Town of Kittery Maine Planning Board Meeting February 27, 2020

ITEM 3 – 8 Wentworth Street – Preliminary Plan Acceptance

Owner/applicant, the Town of Kittery, requests consideration of a preliminary plan for a three-story addition and related site improvements to the Rice Public Library located at 8 Wentworth Street (Tax Map 4, Lot 88) in the Mixed Use – Kittery Foreside (MU-KF).Zone. Agent is Ryan Kanteres, Scott Simons Architects.

BUILDING ELEVATIONS

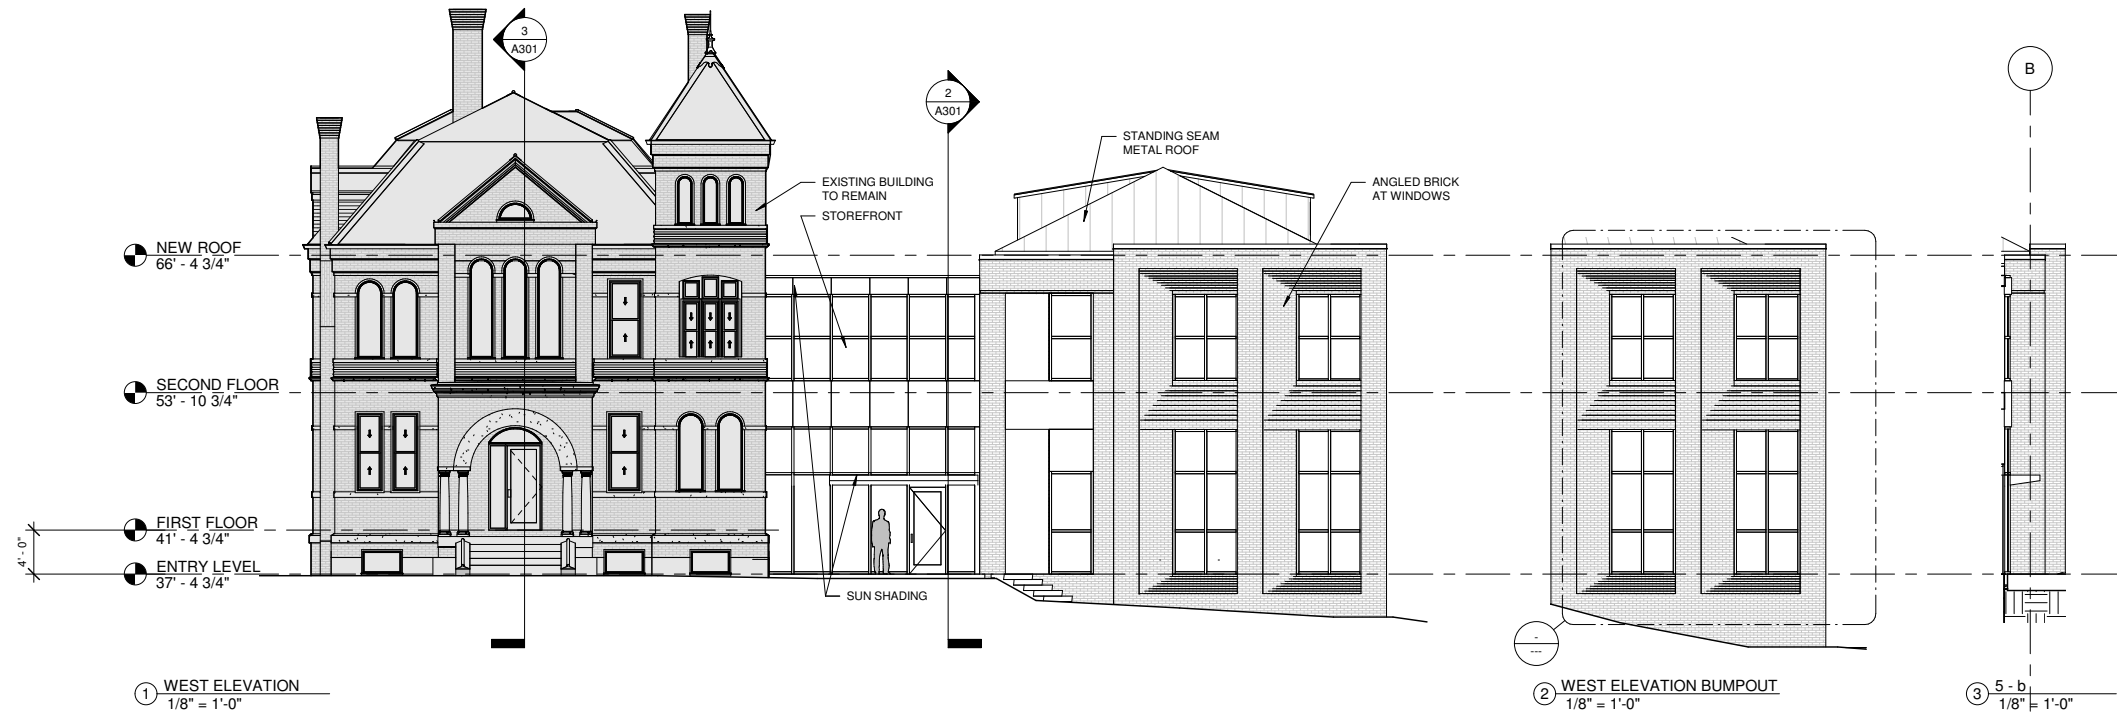
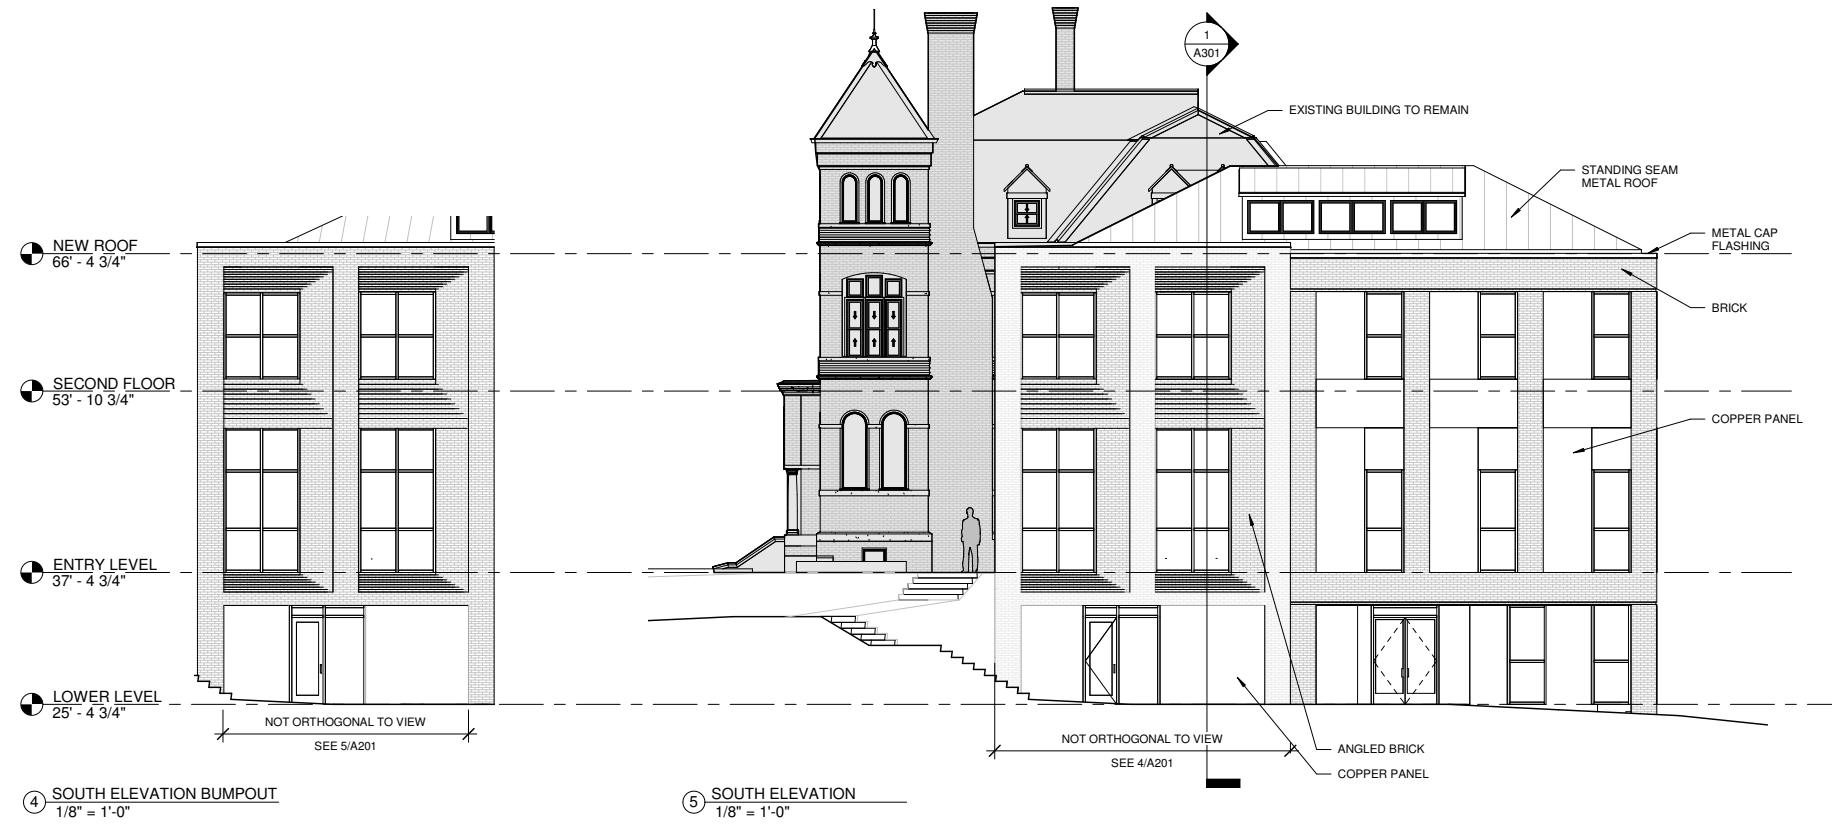
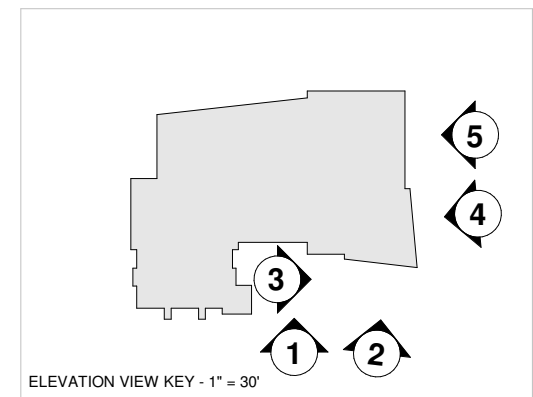
1. The maximum building height in the MU-KF Zone is 40 feet. The original building will remain the tallest structure on the lot.
2. The architectural drawings submitted show that the addition's height will not exceed 40 feet. To demonstrate this, on the second sheet labeled A202, the average grade is shown in the illustration on the top right-hand side of the page as 30 feet, 2 7/16 inches. The height of a building is defined in 16.2.2. Definitions as "*The vertical measurement from the average grade between the highest and lowest elevation of the original ground level to the highest point of the roof beams in flat roofs, to the highest point of pitched roofs or hip roofs...*". The elevation of each story is shown. The new addition's third-story height is therefore: 66 feet, 4 ¾ inches minus 30 feet, 2 7/16 inches. Rounding for ease shows that 66 feet, 5 inches minus 30 feet, 2 inches = 36 feet, 3 inches.

SHEET 4 OF 8

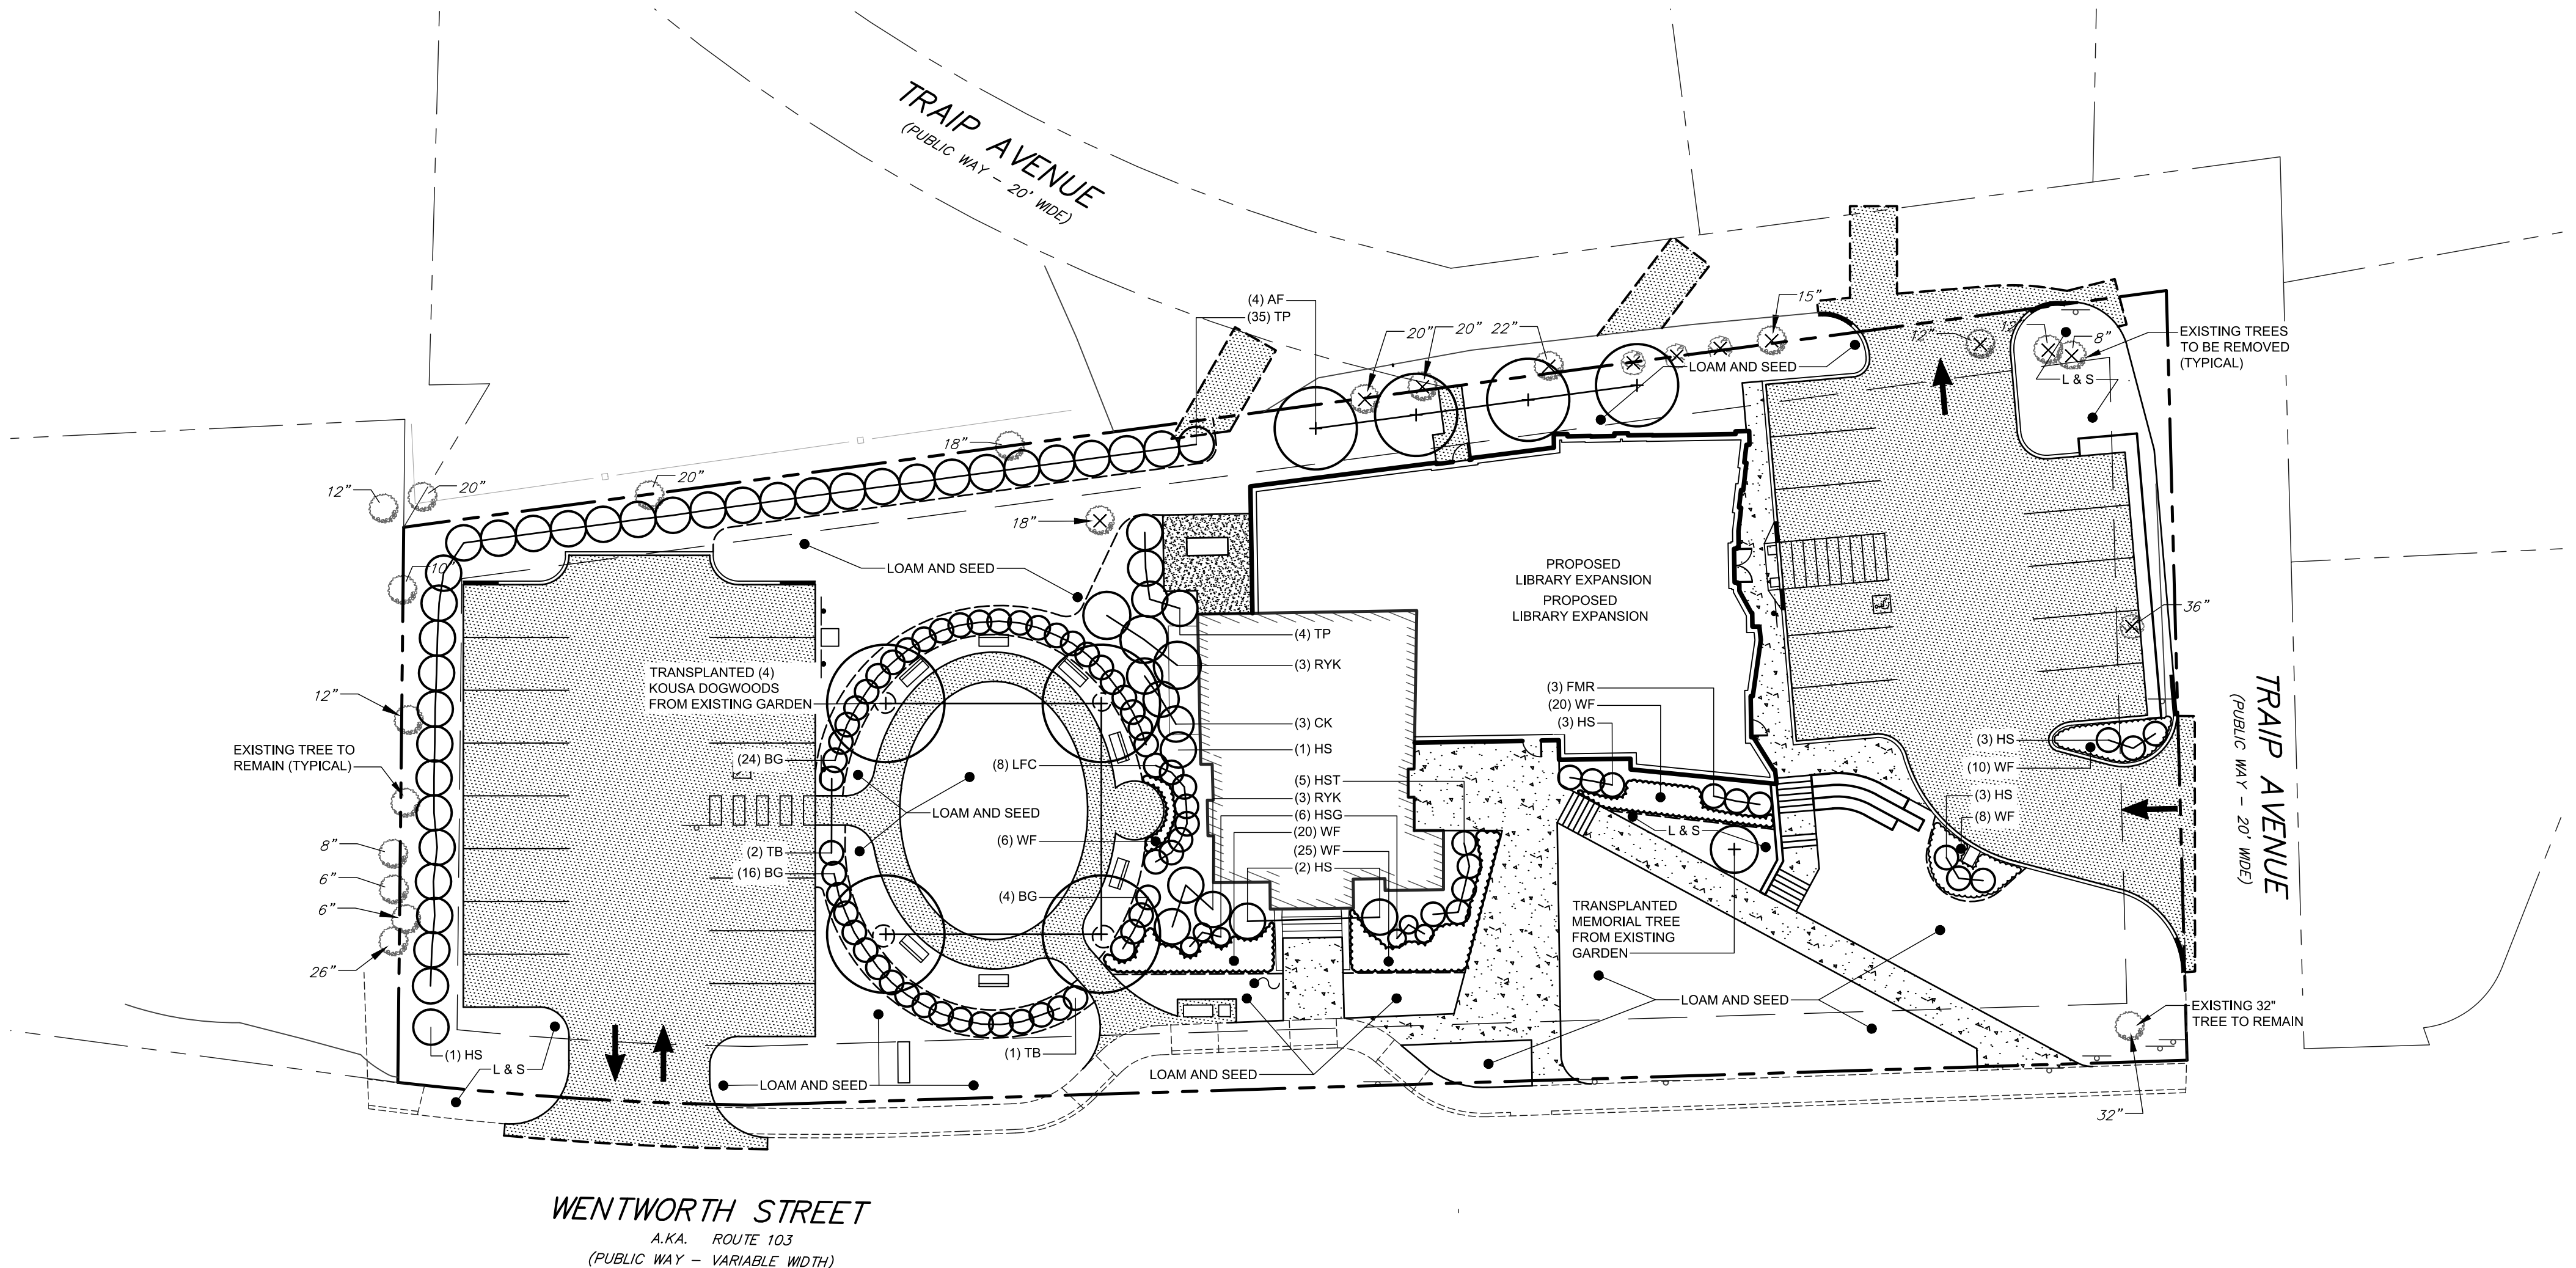
3. The Applicant is proposing 27 off-street parking spaces. No mention was made of two dedicated short-term parking spaces to be located on Wentworth Street which were previously described in the sketch plan. The southern parking lot is proposed to be paved (it is currently gravel) with 10 parking spaces + one ADA-compliant space while the northern parking lot is proposed to accommodate 15 parking spaces + one ADA-compliant space. The number of ADA-compliant parking spaces meets the requirements for each parking lot (1 ADA-compliant space for up to 25 parking spaces). It appears that the north arrow may be backwards on Sheets 2, 3 and 4.
